RE: **Lot 17 Block 11 Unit 5 S.A.D. 227**
8016 Emerald Dr. NW
Grading and Drainage Plan
Engineers Stamp Date 3/9/18 (E10D043)

DRAINAGE AND TRANSPORTATION INFORMATION SHEET (REV 09/2015)

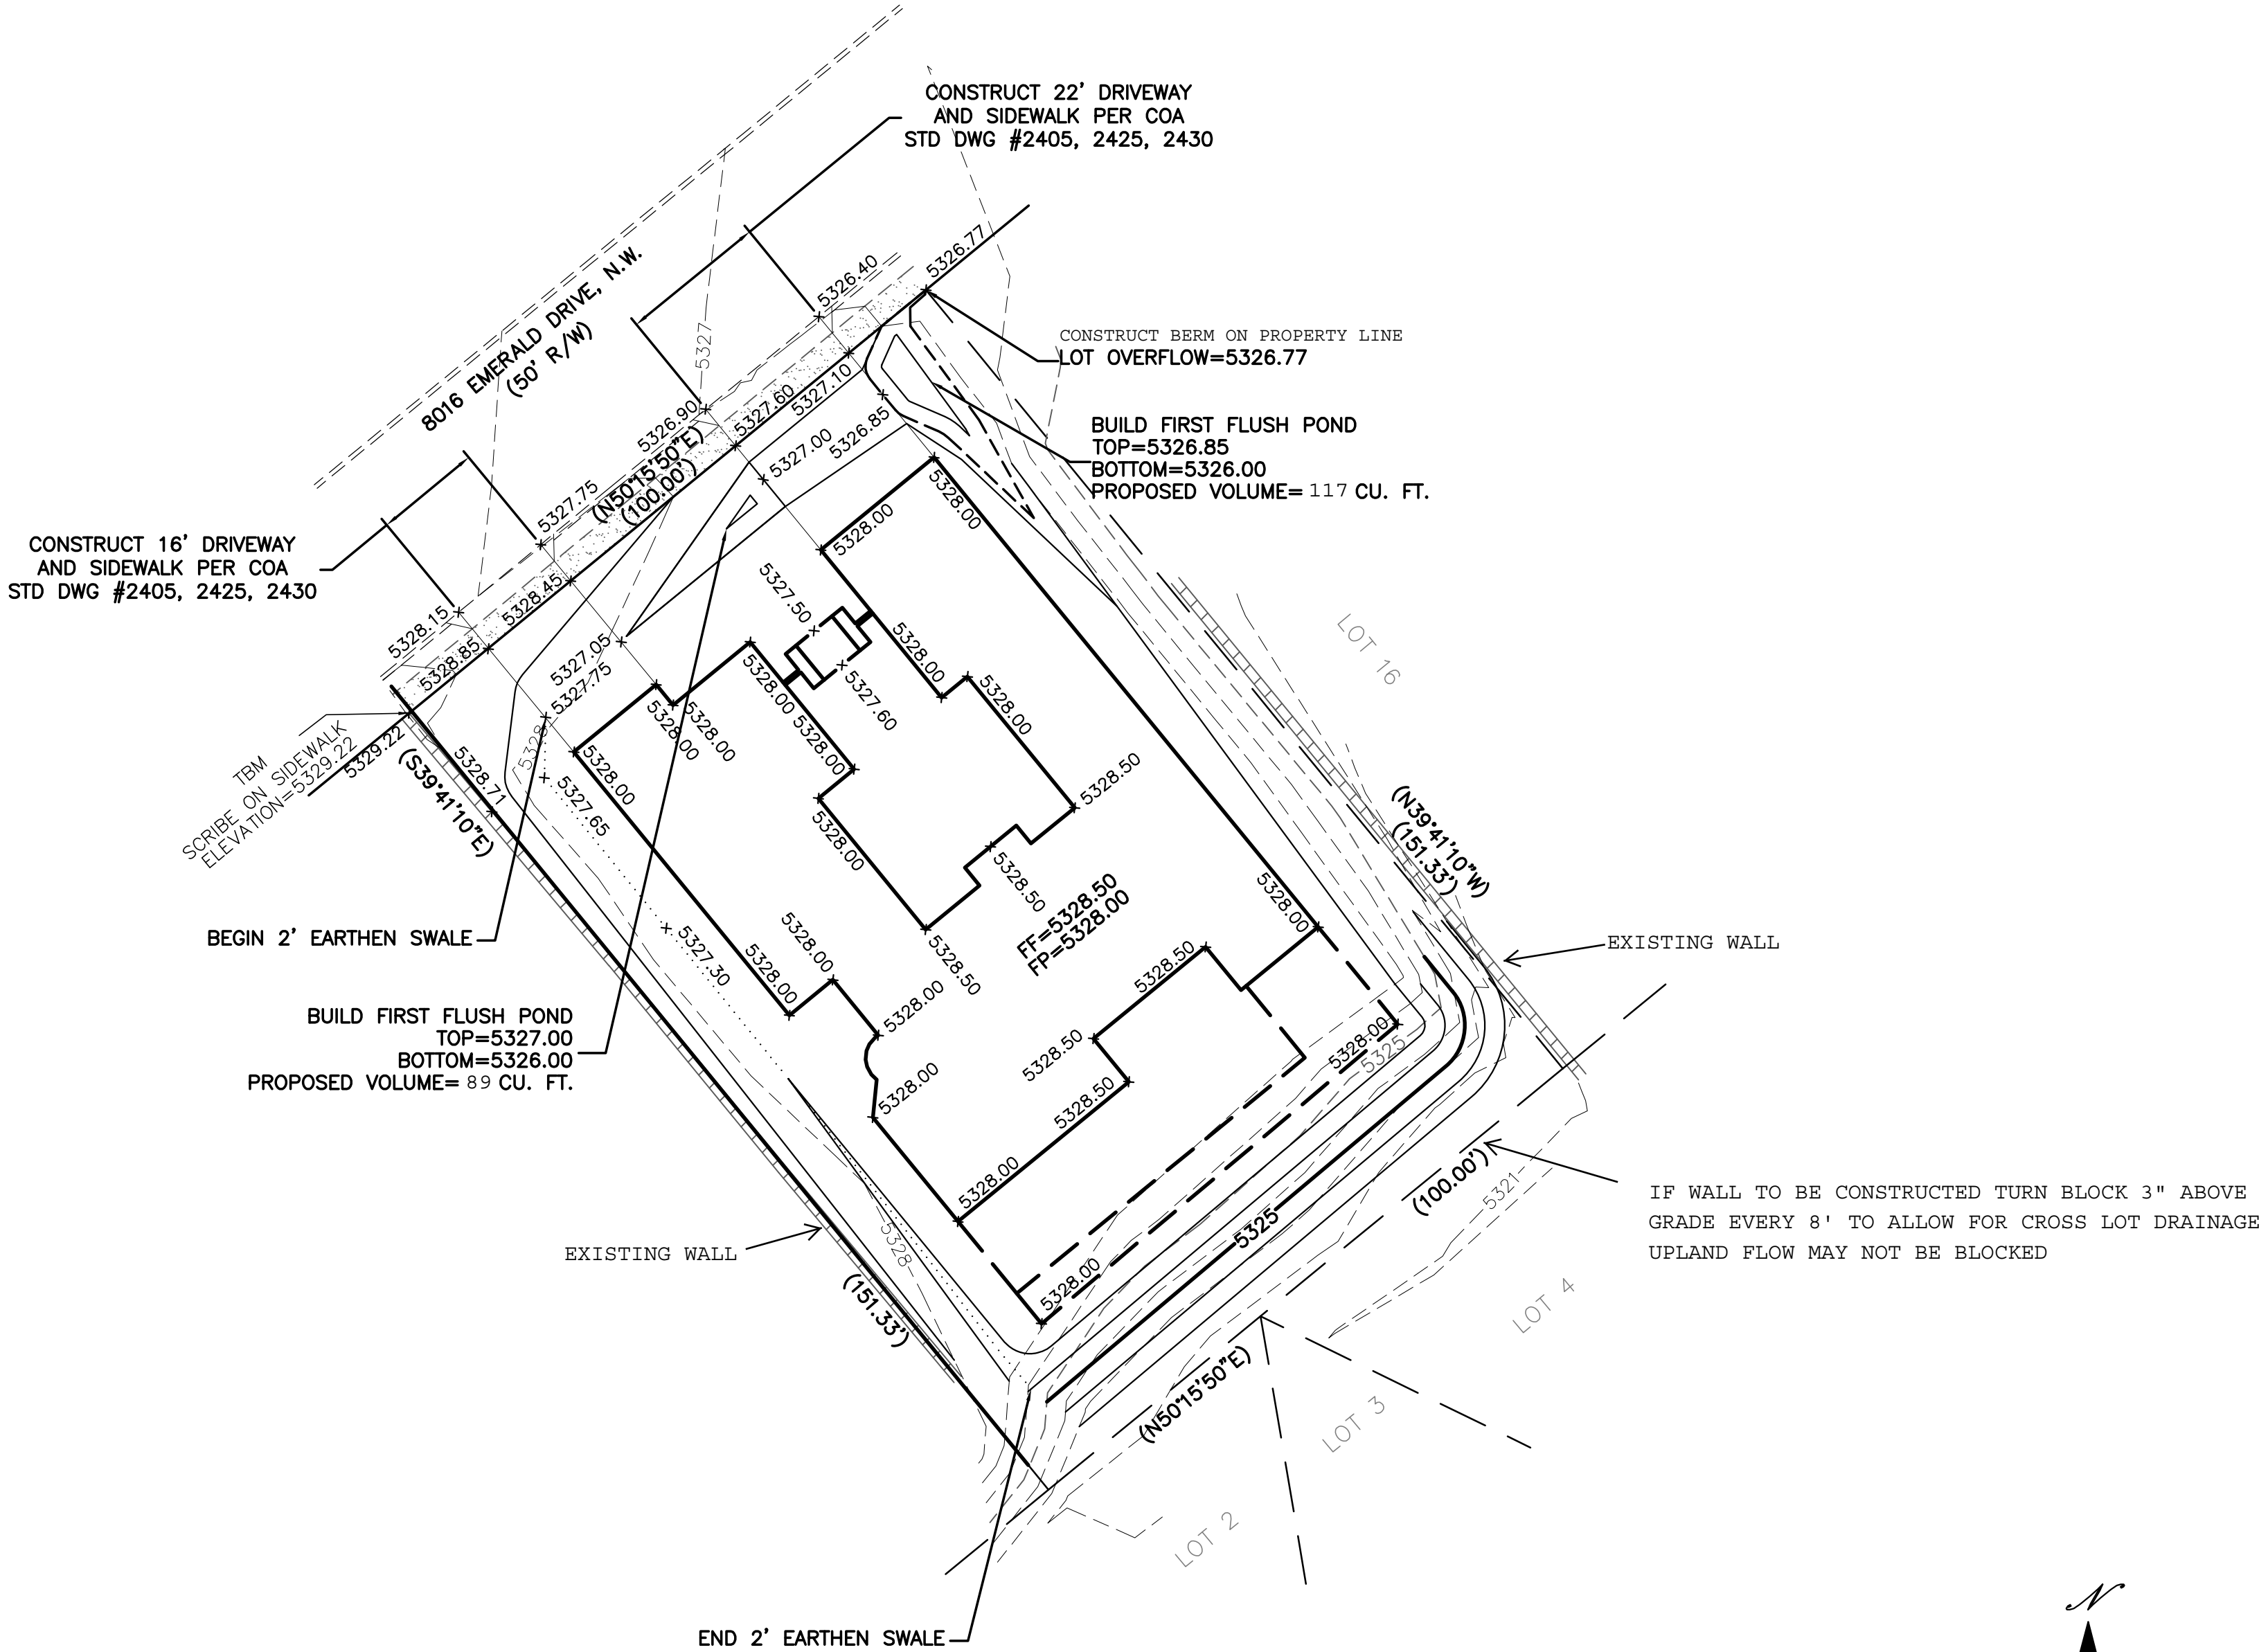
Based upon the information provided in your submittal received 3/12/18, this plan is approved for Grading Permit.

Reiterate to the Owner/Contractor that a separate permit for a garden/retaining wall must be obtained, with the approved G&D plan.

Prior to Building Permit approval, a **Pad Certification** will be required.

Prior to **Certificate of Occupancy release**, Engineer Certification per the DPM checklist of this plan will be required.
